City of Pembroke Pines
Planning & Economic Development Department
601 City Center Way 3rd Floor
Pembroke Pines FL, 33025

Agenda Date:	September 11, 2025	Application ID:	SP2025-0005
Project:	H & M Self-Storage	Project Number:	PRJ2024-0017
Project Planner	Cole Williams, Senior Planner		
Owner:	Raintree at Pines LLC	Agent:	Michelle Diaz-Mendez
Location:	1520 South Hiatus Road	Commission District	1
Existing Zoning:	C-1 (Commercial)	Existing Land Use:	Commercial (Flexibility Rule Applied)
Reference Applications:	ZV2025-0008, ZC 2024-0003, SP2021-08, SP2020-09, ZV 2020-08, SP 2017-03, ZV 2017-02, ZV 2017-03, ZV 2017-04, ZV 2017-14, ZC 2017-02, SP 2015-01, SP 2014-22, MSC 2010-07, SP 2008-02, MSC 2007-71, SP 2006-53, ZC 2005-06, ZC 2005-07, ZC 2003-02, AM 2003-07		
Applicant Request:	Construction of a self-storage facility with associated site, signage, circulation, parking and landscape improvements.		
Staff Recommendation:	Approval subject to the recordation of the underlying plat		
Final:	<input checked="" type="checkbox"/> Planning & Zoning Board	<input type="checkbox"/> City Commission

Date: September 2, 2025
To: SP 2025-0005 file
From: Cole Williams, Senior Planner
Re: Self-Storag

EXISTING TREE DISPOSITION PLAN

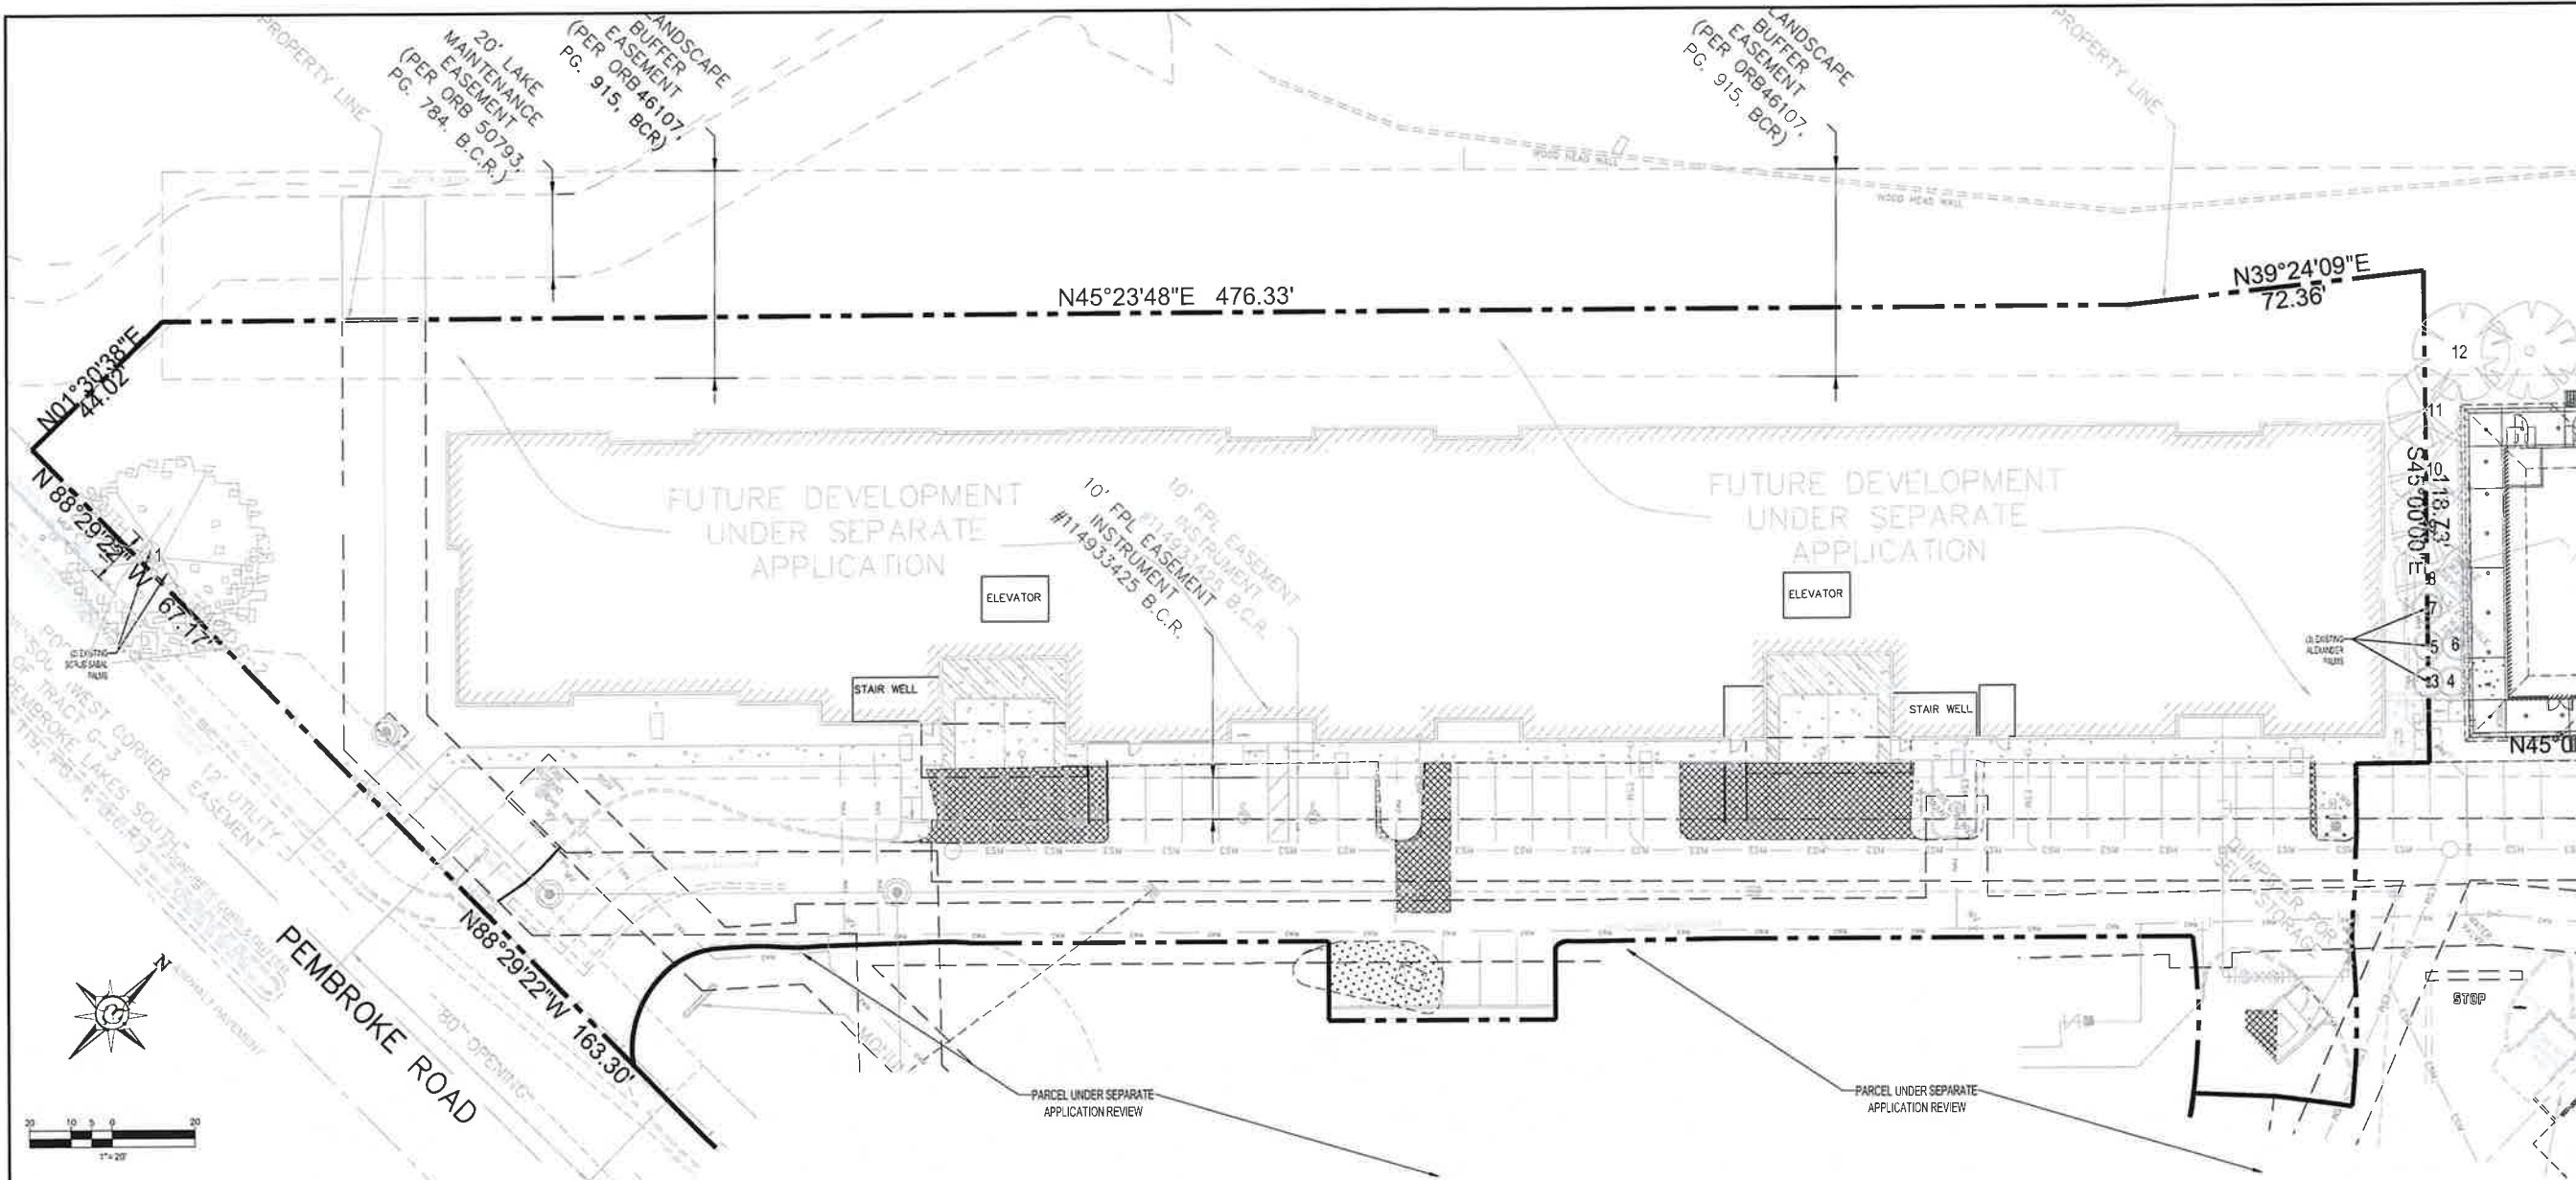
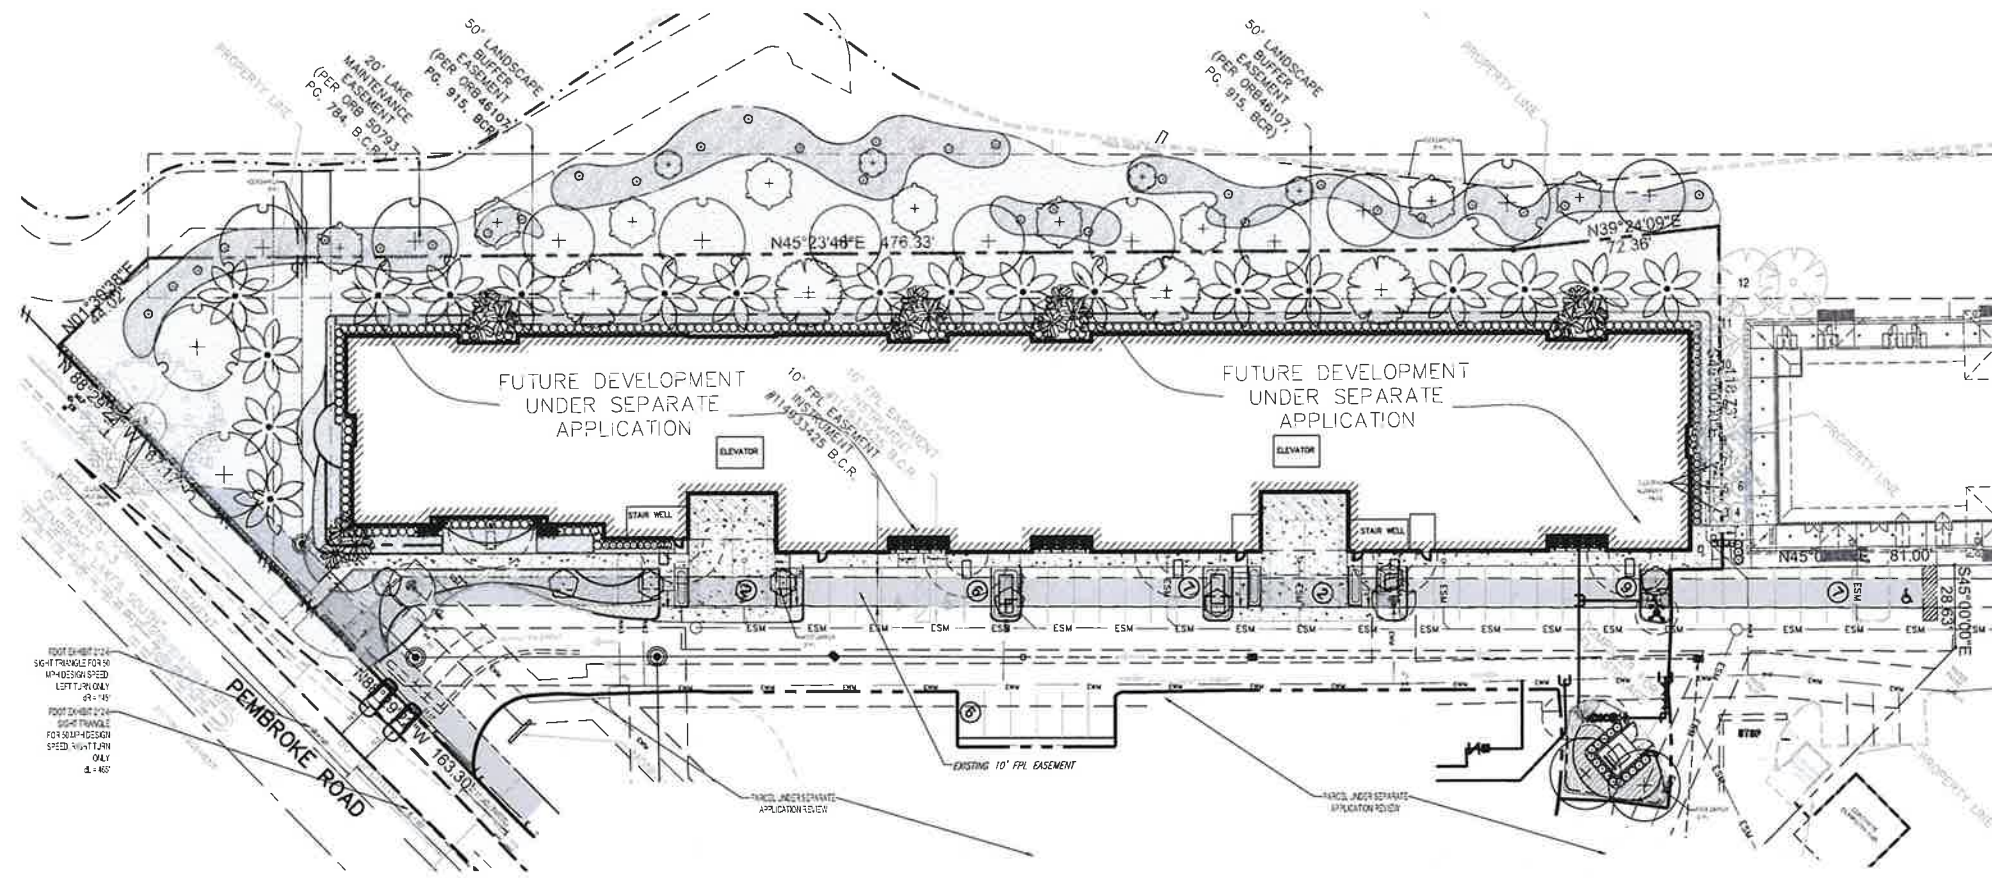
- ~~3. As per BCPA, palms #3, 5, and 7 appear to be within the property lines of the parcel and would count towards minimum landscape requirements. Tree disposition on L-1 to be updated for palm #3 to be noted as "on-site" within comment section.~~

3. As per BCPA, palms #3, 5, and 7 appear to be within the property lines of the parcel and would count towards minimum landscape requirements. **Tree disposition on L-1 to be updated for palm #3 to be noted as "on-site" within comment section.**
